Vogtle Project

PLANT VOGTLE - UNIT 2
NRC DOCKET NUMBER 50-425
CONSTRUCTION PERMIT NUMBER CPPR-109
SPENT FUEL RACKS

Attachment 1 to Letter GN-1479

Attachment 3 to Letter GN-1479

FIGURE 1 · DYNARACK MODEL

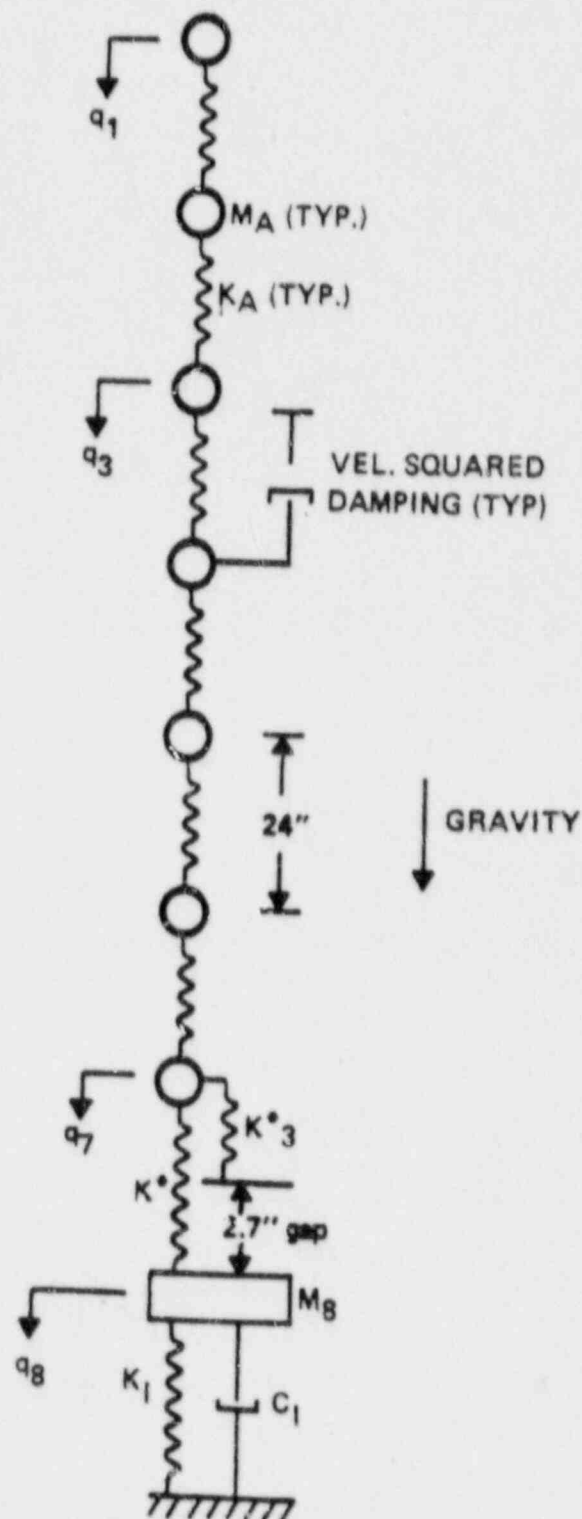
IV. Dropped Fuel Assembly Impact

1. Provide calculations demonstrating the assertion in the submittal that the high shear stresses due to the postulated impact load will be above the active fuel region.
2. Provide calculations showing the effects of the postulated impact load on the rack base plate will not damage the pool liner.

Figure 1 shows the dynamic model of the fuel assembly. Seven masses are used for the fuel assembly. The elasticity of the fuel rods is modelled by non-linear spring elements. The spring element non-linearity consists of a limiting load supporting capability; the limit load is taken as the failure load, under direct compression, of the rod bundle. A non-linear spring and stop element, in parallel, model the supports at the base of the fuel assembly. The stop element acts only if the supports completely crush under impact. Velocity square damping elements are associated with the moving masses.

The impacted structure (support foot, baseplate, or top of rack) is modelled by a mass, spring, and damper. The stiffness, etc., of this element reflects the local characteristics of the particular location being impacted under the given scenario. A time history analysis is undertaken, based on a given initial velocity of the assembly masses, to determine the maximum force in the spring damper element representing the impact body. The initial velocities at time zero are determined using classical momentum equations including the effect of fluid resistances to the drop. For drops to the baseplate or support foot, the drop is assumed to start when the assembly enters the top of the rack with an initial speed $(2gh)^{1/2}$ where $h = 36"$.

<u>Condition</u>	<u>Impact Velocity (ft/sec)</u>	<u>Maximum Impact Load (lb)</u>	<u>Comments</u>
(i)	4.225	137,100 (on support foot)	Max. support foot load is less than the SSE limiting value.
(ii)	20.45	180,000# (on baseplate)	Welds will fail locally but surrounding welds will support the assembly; no liner impact will occur.
(iii)	13.9	50,840# (assuming 2 cells are impacted)	Max. depth of indentation is less than 2.75 inches.

FIGURE 4 - TYPICAL CELL ELEVATION

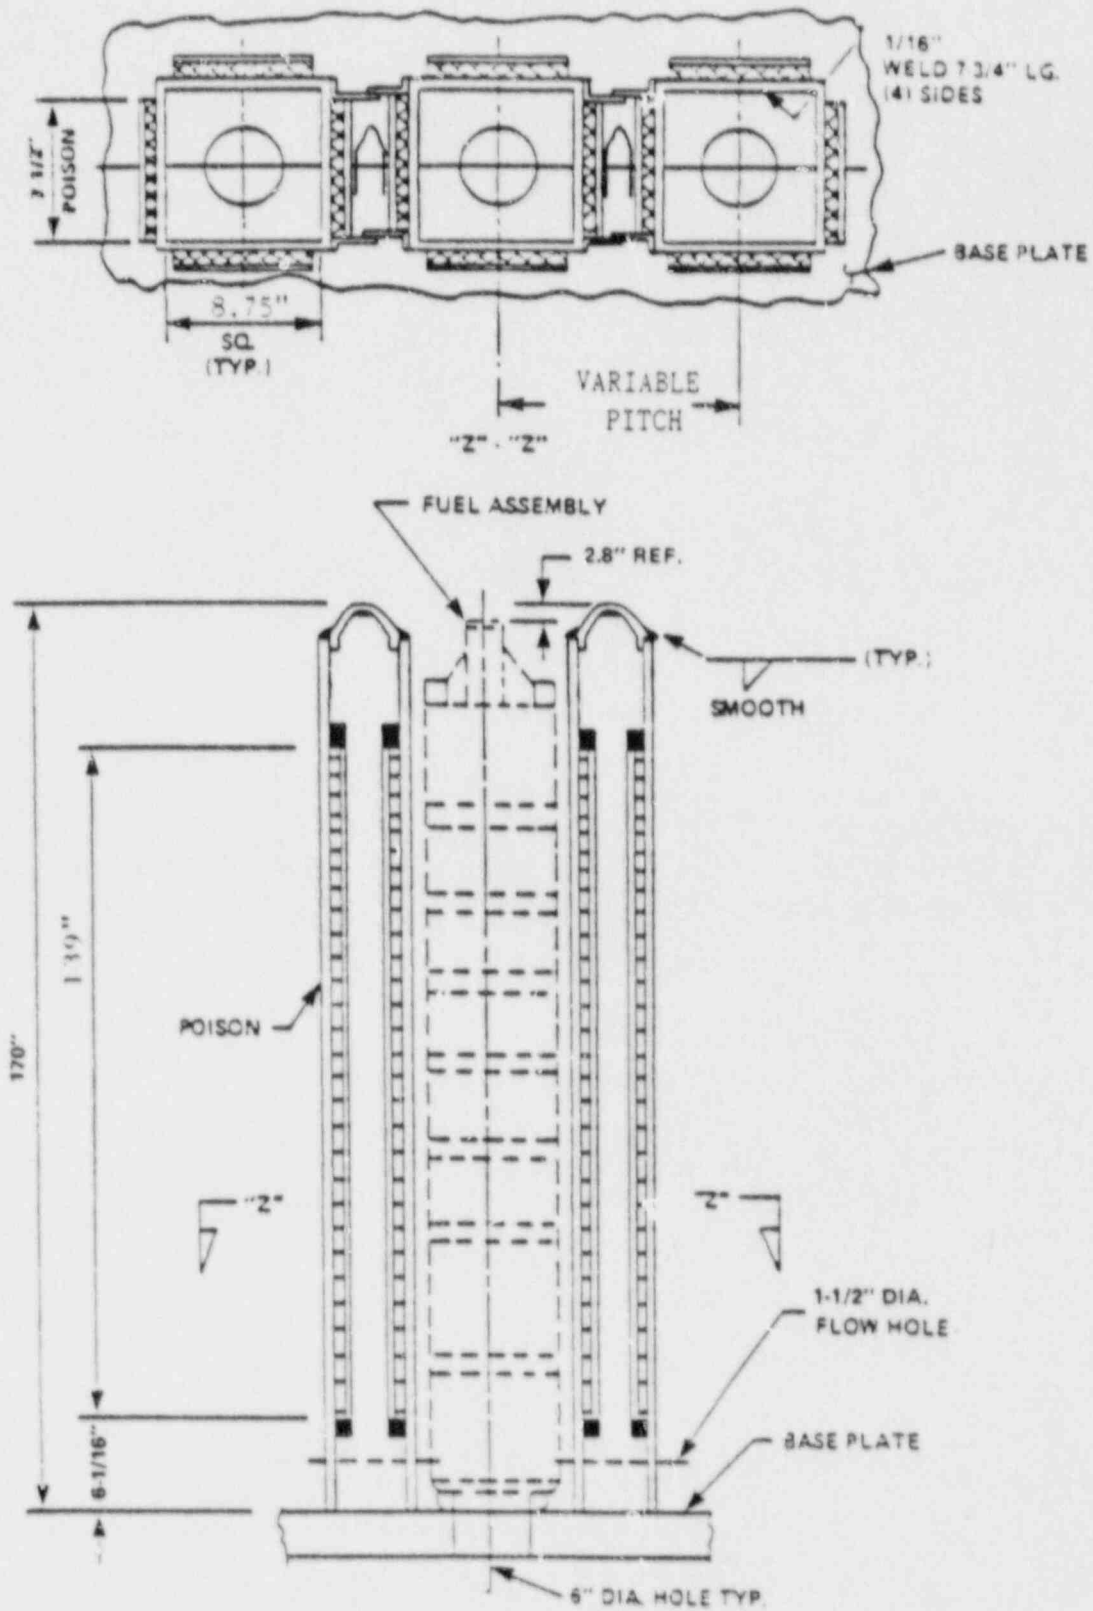
The first change involves the boraflex coverplate. Initially the boraflex poison was held in place by a flat coverplate attached to the sides of tubes with a series of spot welds. As a result of a slightly undersized coverplate and stresses during fabrication and testing, a few of the spot welds detached. Auxiliary retainers are now installed between the interior cells which hold the coverplates in place along their entire length. The exterior cells have been fully inspected.

The poison sheet can now be installed in the picture frame space, and covered with .020" thick (nominal) sheathing. The "sheathing" overlaps the picture frame strips at the bottom, side and top, and is spot welded to them. Finally, 1-1/2" diameter flow holes are punched near the bottom on all four sides of this "composite box assembly." The top of the box is equipped with a lead-in as discussed later (Fig. 4). Added lateral support to the sheathing is provided in the form of auxiliary retainers wherever the sheathing to box weld integrity could not be verified during fabrication. Figures 4 and 5 show the auxiliary retainers schematically.

In the next step of manufacture, the "base plate" is attached to the bottom edge of the boxes. The base plate is a 5/8" thick austenitic stainless steel plate stock which has 6" hole (Ref. Fig. 4) turned out in a pitch identical to the box pitch. The base plate is attached to the cell assemblage by fillet welding the box edge to the plate by reaching in through the bottom hole using a "goose neck" welding head (2 sides only; other 2 sides welded from outside) (Ref. Fig. 4).

FIGURE 5 - UNIT 2 SPENT FUEL RACK STORAGE CELL GEOMETRY, TOP VIEW

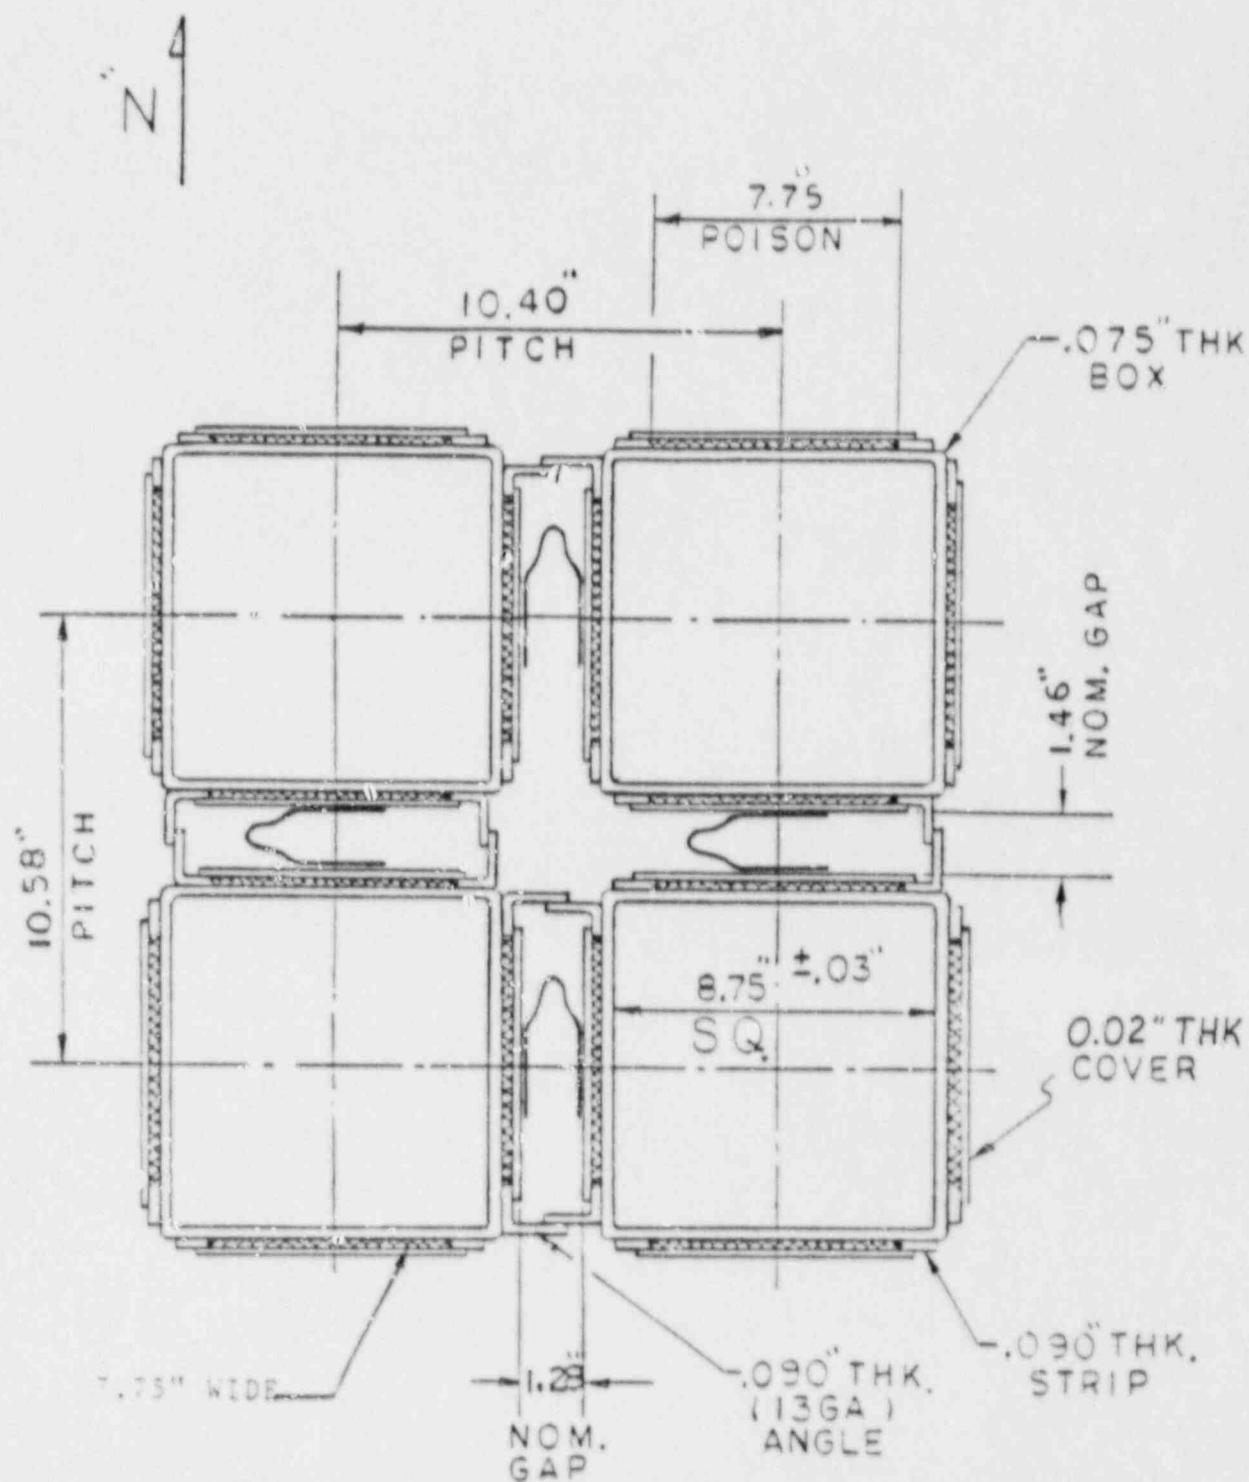
The second change involves the spacing between the cells. Fabrication activities were underway on the first five racks when it was determined that the spacing between cells (watergap) was not consistent with the dimensions used in the criticality analysis attached to our December 23, 1987 letter. The spacing between cells was measured on the first five racks and it has been determined that the revised criticality analysis based on as-built dimensions of rack A-5, using Westinghouse standard 17 x 17 fuel, bounds all existing and future racks. Increased attention has been given to the precise placement of cells during the manufacturing process beginning with the sixth rack (B-2). This was confirmed by a criticality analysis based on the as-built dimension of the sixth rack (B-2) which was manufactured with the improved process. The results of the analysis of rack B-2 is also being incorporated into the criticality report. The revised criticality analyses demonstrate that K_{eff} values for all racks remain less than 0.95 when using standard Westinghouse 17x17 fuel, which is the current fuel design for Vogtle Electric Generating Plant Units 1 and 2.

Having fabricated the required number of the composite box assemblies, they are joined together in a fixture in the manner shown in Fig. 5. The pitch between the box centerlines is 10.40" (nominal) in one principal direction and 10.58" (nominal) in the other principal direction. The fabrication procedure in either direction is identical, since the protruding angles from adjacent boxes overlap and are fillet welded to each other.

Figure 5 shows an array of boxes attached to each other. Fig. 5 also illustrates that the joining pattern results in a well designed shear flow path; and essentially makes the box assemblage into a multiflanged beam type of structure.
